**SHEARON HARRIS NUCLEAR POWER PLANT, UNITS 2 AND 3
DOCKET NOS. 52-022 AND 52-023
RESPONSE TO REQUEST FOR ADDITIONAL INFORMATION LETTER NO. 019 RELATED TO
STABILITY OF SUBSURFACE MATERIALS AND FOUNDATIONS**

**Shearon Harris Nuclear Power Plant Units 2 and 3
Response to NRC Request for Additional Information Letter No. 019 Related to
SRP Section 02.05.04 for the Combined License Application, dated September 25, 2008**

NRC RAI #: 02.05.04-1

MASW Profiles at HAR 2 (Area A)

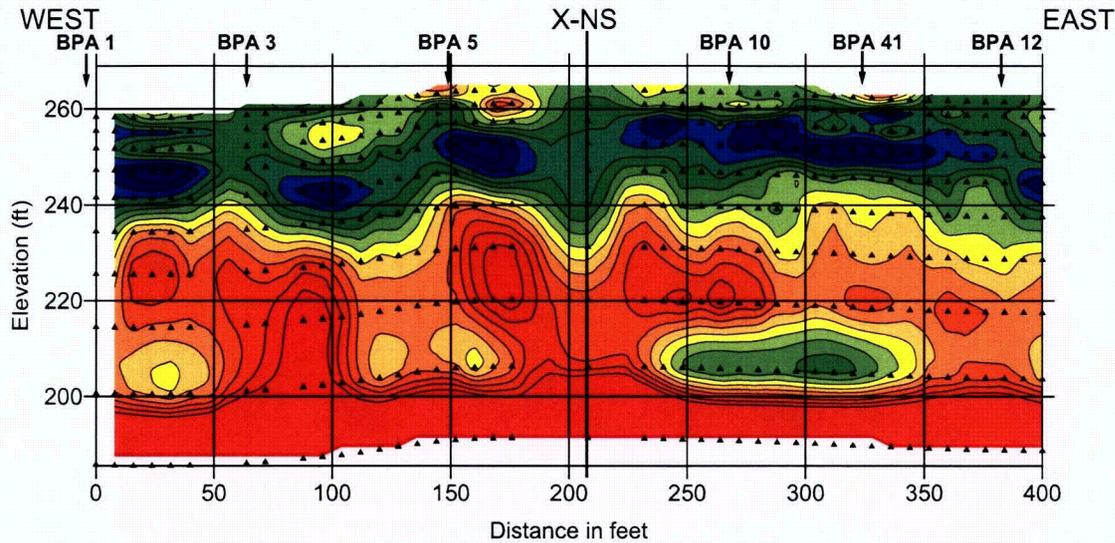
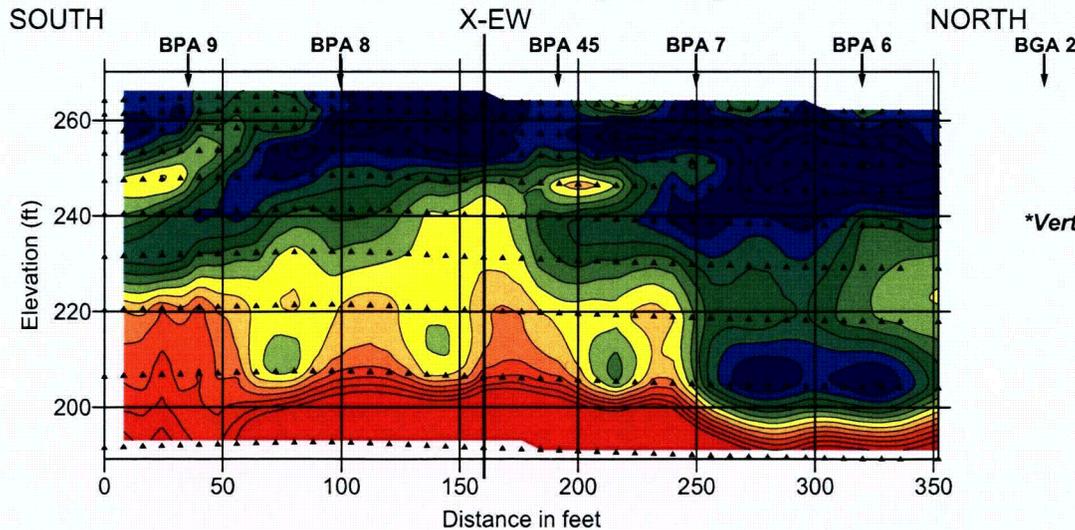
- The locations of boreholes BPA-6 and BPA-7 are shown along the MASW profile on Figure A-3. No supplemental V_s data from other methods are available at these locations. As shown on Figure A-3, a V_s inversion is indicated commencing north from BPA-7 and extending past BPA-6, between approximate elevation 195 and 215 feet. The MASW data indicate that the low V_s within this interval is less than 1800 fps. Review of the BPA-7 borehole log does not indicate any features (low RQD or recovery, clay seams, etc.) that would support such an inversion in this elevation range. The BPA-6 borehole log shows some reduction of RQD in this elevation range, but nothing to indicate such a low V_s . Deeper weathered rock and soil intervals encountered at BPA-6 (especially between elevation 160 and 175 feet) are below the depth extent of the MASW investigation.

Figure A-5: V_s Data comparisons - Near BPA-5

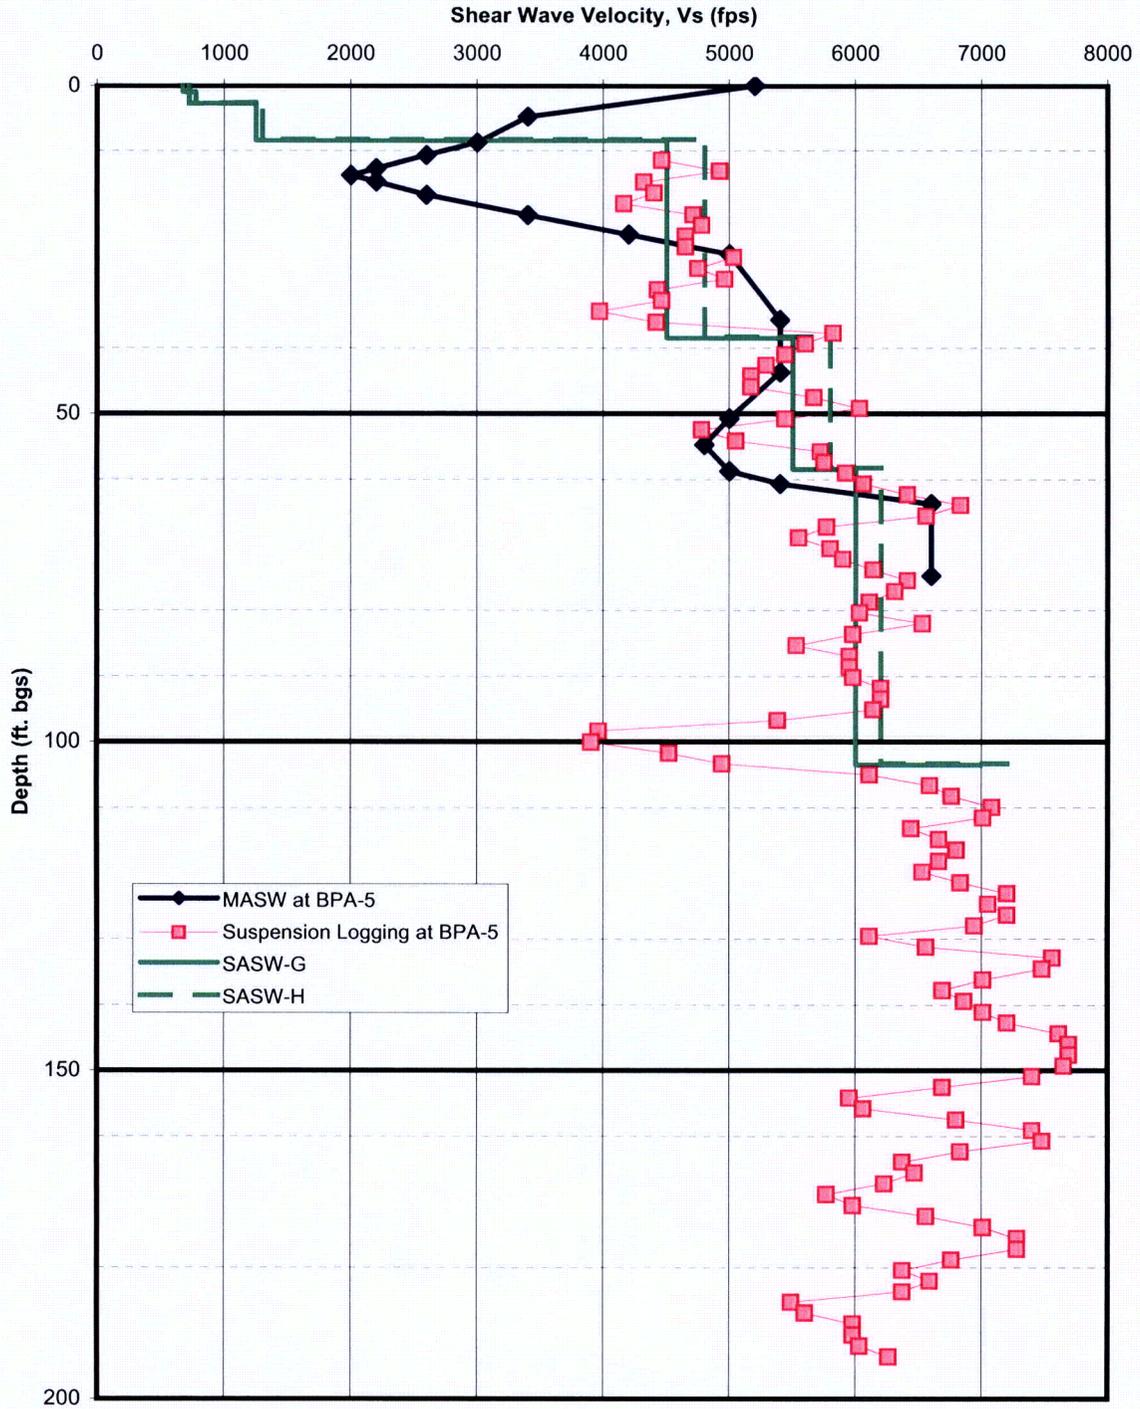
- Near BPA-5, as shown on Figure A-5, the MASW survey results indicate significantly lower V_s than the associated suspension logging and SASW methods in the shallow interval between approximate depths of 10 to 20 ft bgs, directly under an anomalous high velocity reported in the upper few feet of the MASW profile (over 5000 fps at ground surface). Below this interval, between approximately 30 and 35 ft bgs, the MASW survey does not detect a slight inversion observed in the suspension logging results. In this location, the size of the inversion detected by the suspension logging method may be too thin to affect the MASW results. Other than these shallow intervals, the deeper MASW results are generally consistent with the other methods.

**Figure A-6: V_s Data Comparisons - Near BPA-41
(Including BPA-47 and BPA-48 Borehole V_s Data)**

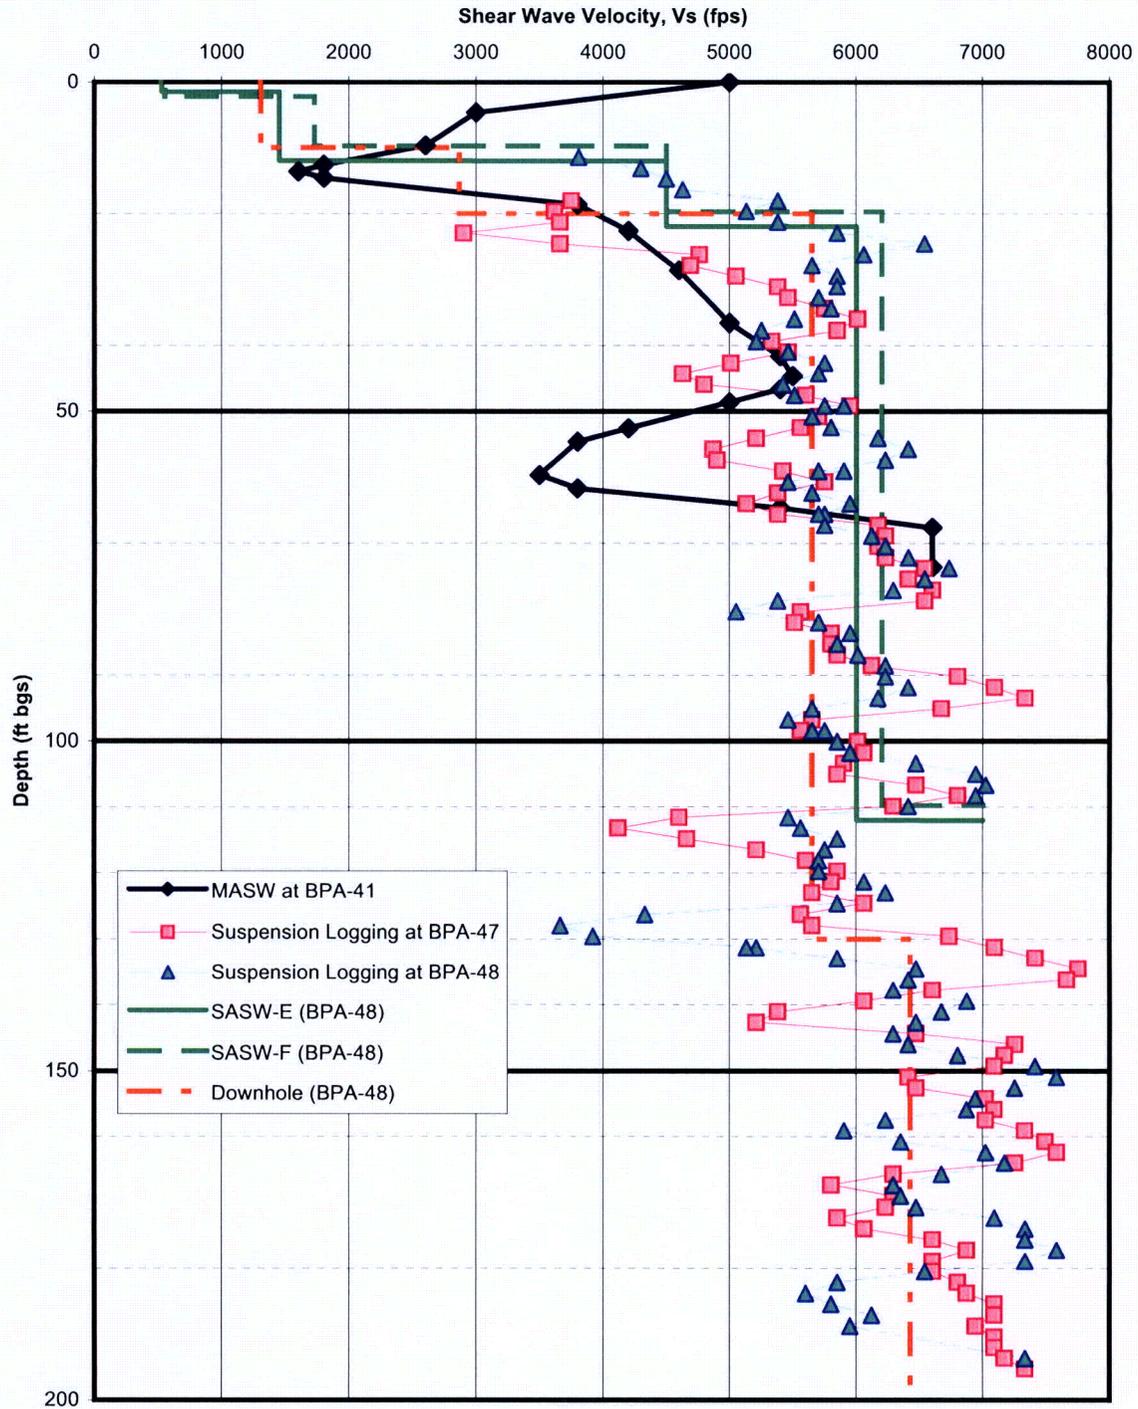
- MASW survey results near borehole BPA-41 are shown on Figure A-6, along with the suspension logging results from nearby boreholes BPA-47 and BPA-48 and downhole and SASW survey results at borehole BPA-48. These borehole locations relative to the MASW survey line are shown on Figure A-1; the MASW survey line was advanced near the BPA-41 location, and BPA-47 and BPA-48 bound this location to the north and south. As shown on Figure A-6, the MASW results are generally consistent with results of other methods performed north and south of BPA-41. One significant exception is the low- V_s interval shown on the MASW profile between approximate depths of 50 to 65 ft bgs, in which the lowest MASW V_s result (approximately 3500 fps) is approximately 40 percent lower than the corresponding results from other methods at nearby boreholes BPA-47 and BPA-48 at the same depth. Review of the BPA-41 borehole log, which was advanced at the MASW profile location, does not indicate any features such as low RQD, low recovery, or clay seams within this depth range that would indicate such an inversion is present.

Figure A-7: V_s Data Comparisons - Near BPA-25

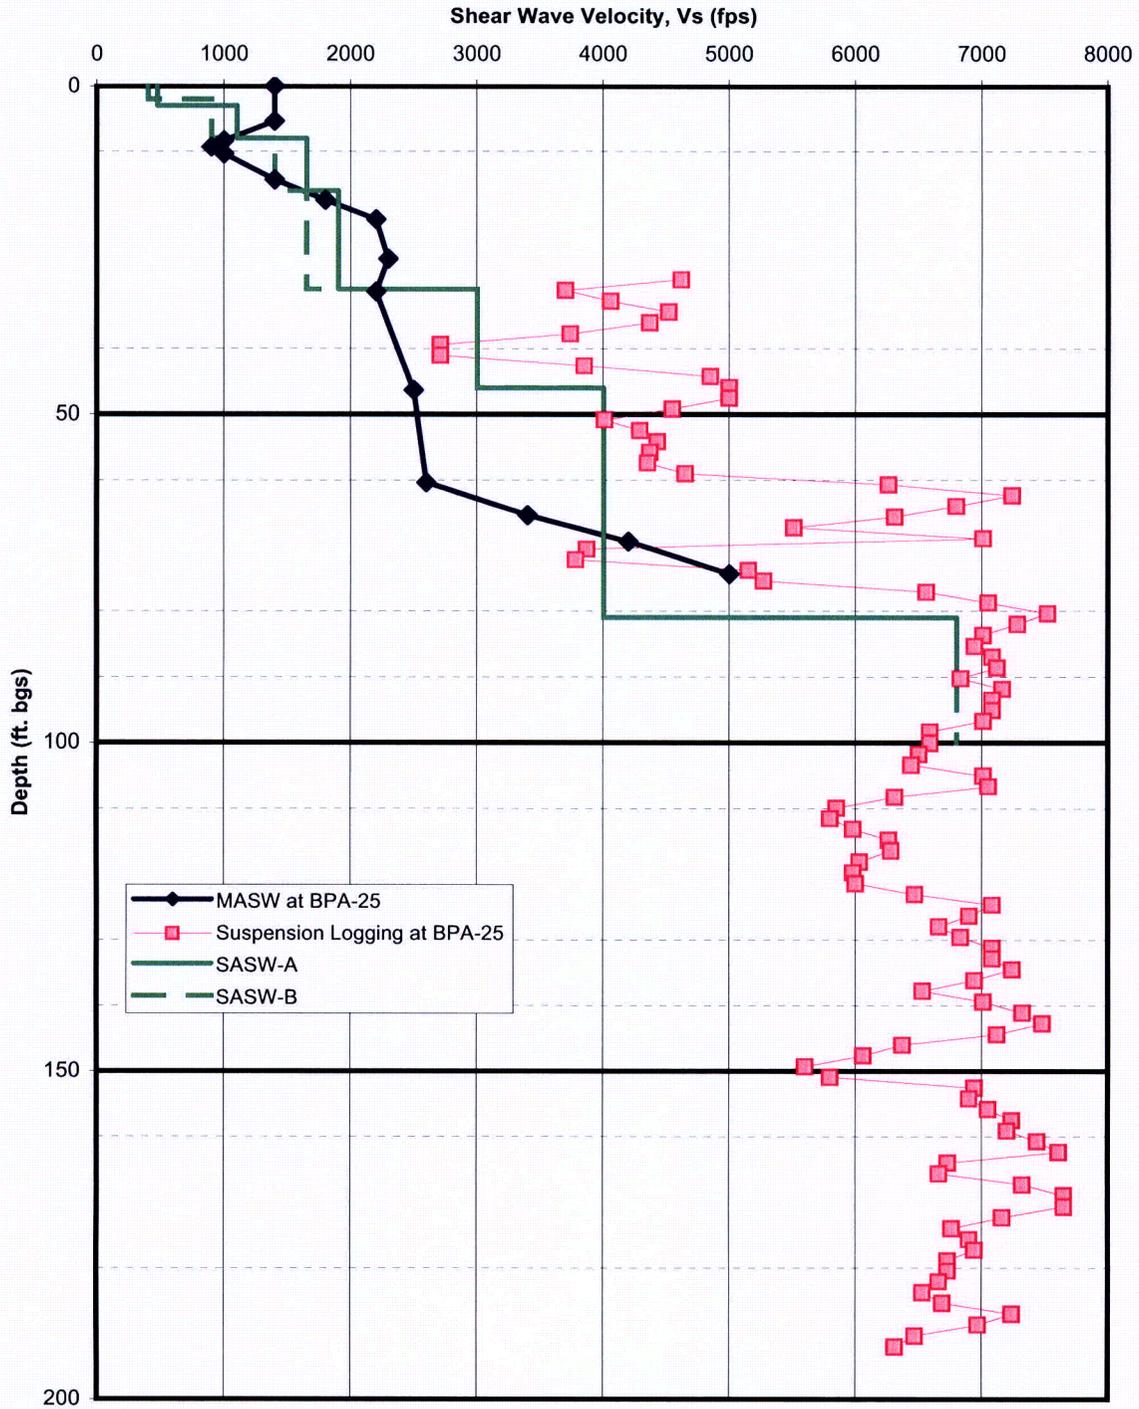
- Near BPA-25, as shown on Figure A-7, the MASW survey results indicate significantly lower V_s than the associated suspension logging and SASW methods between approximate depths of 30 to 70 ft bgs. The MASW results are typically 20 to 50 percent lower than those

from the other methods in this depth range. This is a depth interval where a few relatively low V_s values were observed among the predominantly higher V_s values in the suspension logging results, due to differential weathering and the occurrence of thin fracture intervals and clay seams; therefore, V_s does not increase consistently with depth. The V_s results approximately 30 feet west of the BPA-25 location on the MASW profile are closer to, but still lower than, results from suspension logging and SASW profiles at BPA-25, as shown on Figure A-4.

**Figure A-8: V_s Data Comparisons - Near BPA-27
(BPA-49 Located ~ 60 ft. NE of MASW and SASW)**

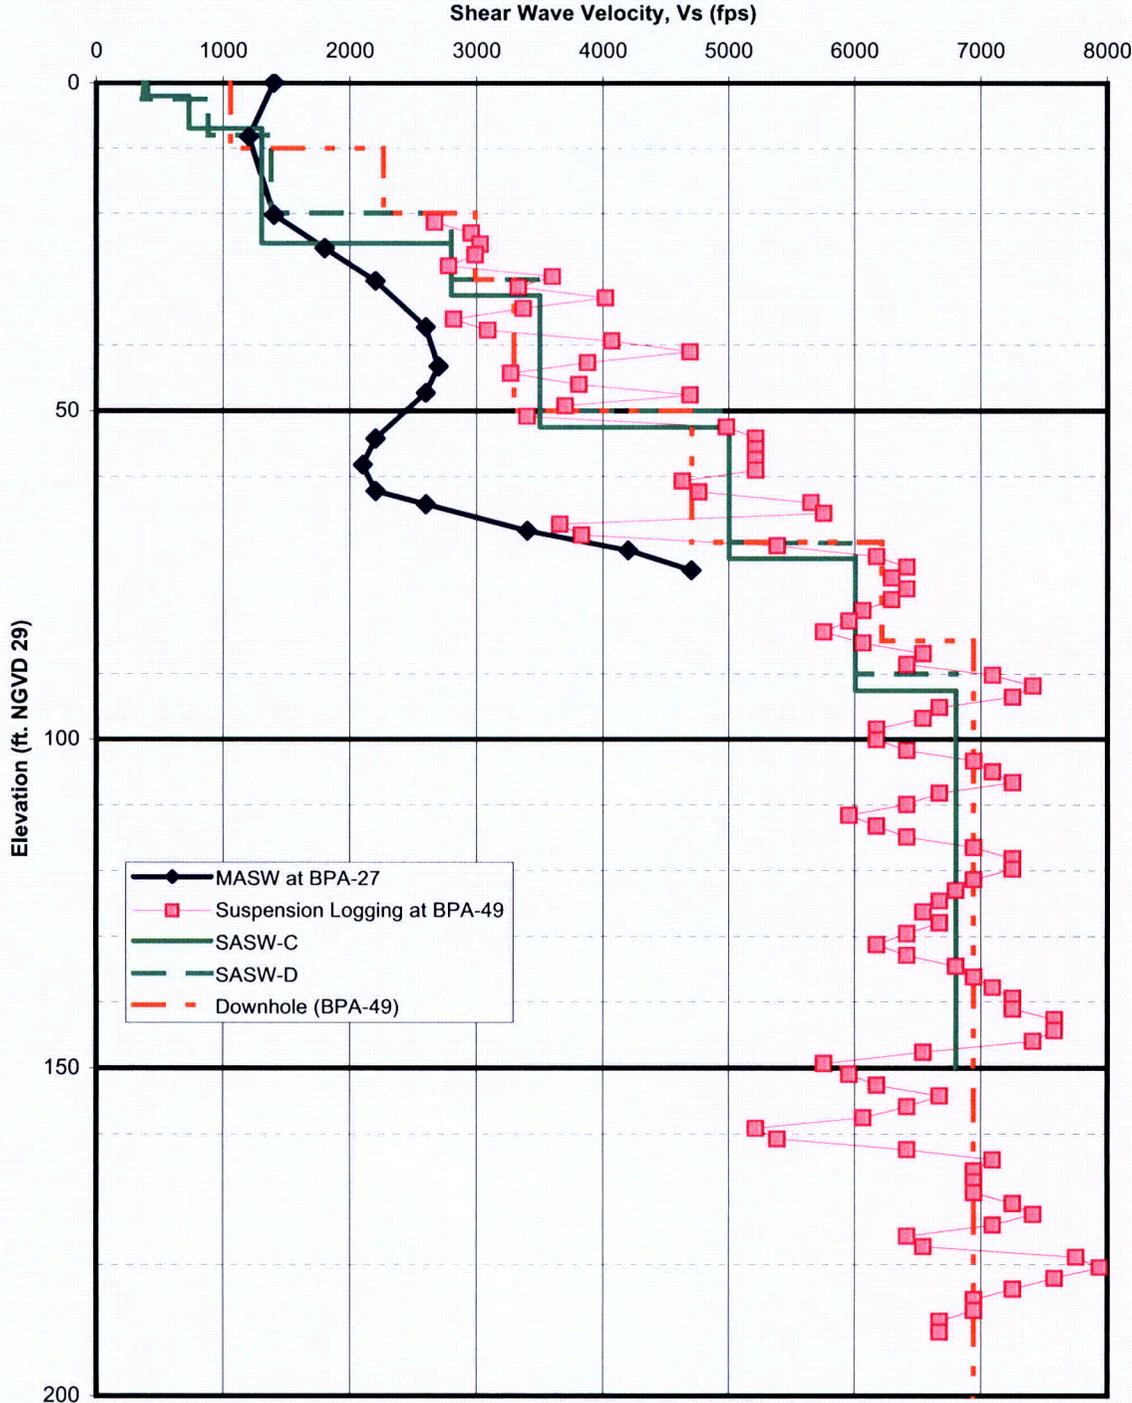
- Near BPA-27, as shown on Figure A-8, the MASW survey results indicate significantly lower V_s than the other methods between approximate depths of 25 to 65 ft bgs. As with BPA-25, this is a depth interval where relatively low V_s values were observed among the predominantly higher V_s values in the suspension logging results, due to differential weathering and the occurrence of thin fracture intervals and clay seams; therefore, V_s does not increase consistently with depth. The suspension logging and downhole survey results shown on Figure A-8 were performed in borehole BPA-49, which is located approximately 60 feet east of the MASW location, whereas the SASW survey was collocated on the MASW line and centered very close to BPA-27. The lowest MASW result in this elevation interval (V_s of approximately 2100 fps at approximately 58 ft bgs) is more than 50 percent lower than the results of other methods at similar depth.
